# UNITED STATES PATENT AND TRADEMARK OFFICE

APPLICATION NO.	FILING DATE	FIRST NAMED INVENTOR	ATTORNEY DOCKET NO.	CONFIRMATION NO.
10/591,510	05/21/2007	Eugen Kloos	LZ-116PCT	1654
40570	7590	11/08/2010	EXAMINER	
Lucas & Mercanti LLP 475 Park Avenue South New York, NY 10016			BURCH, MELODY M	
ART UNIT		PAPER NUMBER		
3657				
MAIL DATE		DELIVERY MODE		
11/08/2010		PAPER

<b>Office Action Summary</b>	<b>Application No.</b> 10/591,510	<b>Applicant(s)</b> KLOOS ET AL.
	<b>Examiner</b> Melody M. Burch	<b>Art Unit</b> 3657

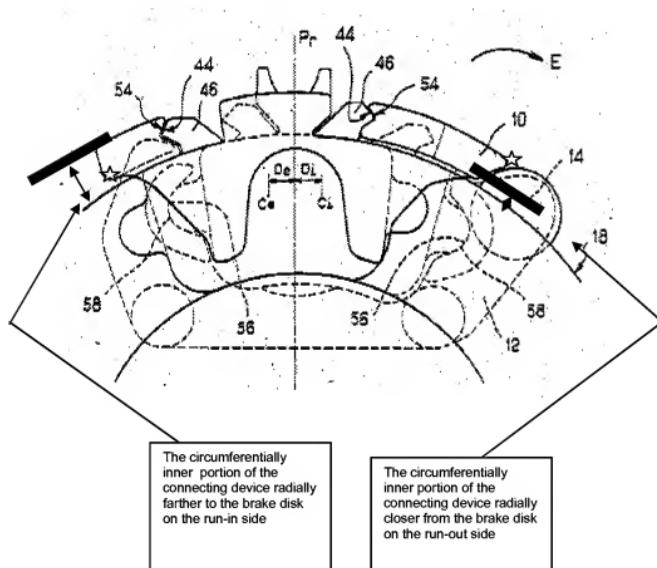
Re: claims 1 and 3-8. Mery et al. show in figure 1 a disk brake with a brake disk 18 that has a preferred direction of rotation; a first brake pad 40 with a first center of gravity  $C_i$  on a first side of the brake disk 18; -- a second brake pad 42 with a second center of gravity  $C_e$  on a second side of the brake disk ; -- a caliper 10 for transmitting the braking forces generated by the second brake pad to the first side of the brake disk, with a first caliper arm or arm on which element number "38" is located on the first side of the brake disk, a second caliper arm or arm on which reference character "De" is located on the second side of the brake disk, and a connecting device (one portion shown at the bottom of the lead line of number 56 and the other portion shown in the area of the end of the lead line of number 10) for joining the first caliper arm with the second caliper arm; and a clamping device 36, which has a center axis perpendicular to the brake disk and is designed to force the first brake pad against the brake disk, wherein the second center of gravity, both in the position of rest of the brake and when the brake is actuated, is offset relative to the first center of gravity by a predetermined first distance in the direction of a brake disk run-out side corresponding to the preferred direction of rotation of the brake disk as shown in figure 1, and the second caliper arm is offset relative to the first caliper arm by a predetermined second distance in the direction of the brake disk run-out side as shown in figure 1, characterized by the fact that wherein the circumferential inner portion of the connecting device is radially closer

to the brake disk on the brake disk run-out side than on a brake disk run-in side, at least in the region in which it spans the brake disk as shown in figure 2.

Alternatively, one could interpret the claim such that the circumferentially inner portion in the area of the right star in the annotated figure on pg. 6 is the connecting device radially closer to the brake disk on the run-out side and the circumferentially

inner portion of the connecting device in the area of the left star in the annotated figure on pg. 6 is the connecting device radially farther from the brake disk on the run-in side.

7. Applicant's arguments filed 10/27/10 have been fully considered but they are not persuasive. Examiner notes that the arguments with respect to the rejection using Mery et al. are moot in light of the new interpretation of Mery set forth in the annotated figure on pg. 4 of the instant Office action. Examiner notes that the new interpretation was necessitated by Applicant's amendment.

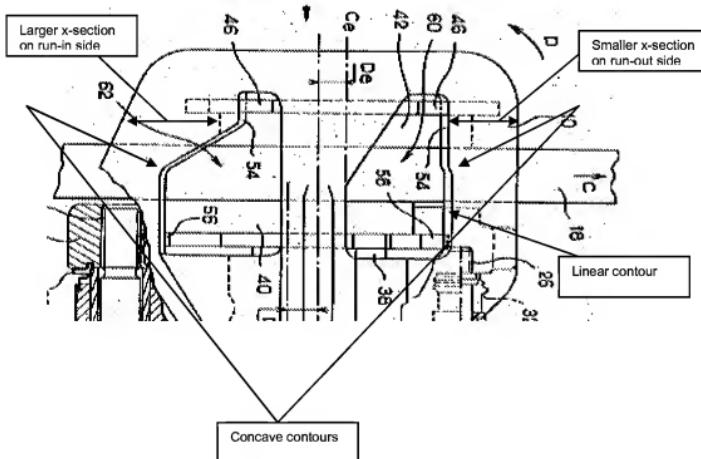
Re: claims 10-12. Mery et al. show in the annotated figure below the limitation wherein in the projection parallel to the brake disk, the opening has a concave contour on the brake disk run-in side and a more or less linear contour on the brake disk run-out side and that this more or less linear contour forms an acute or obtuse angle with the plane of the brake disk.
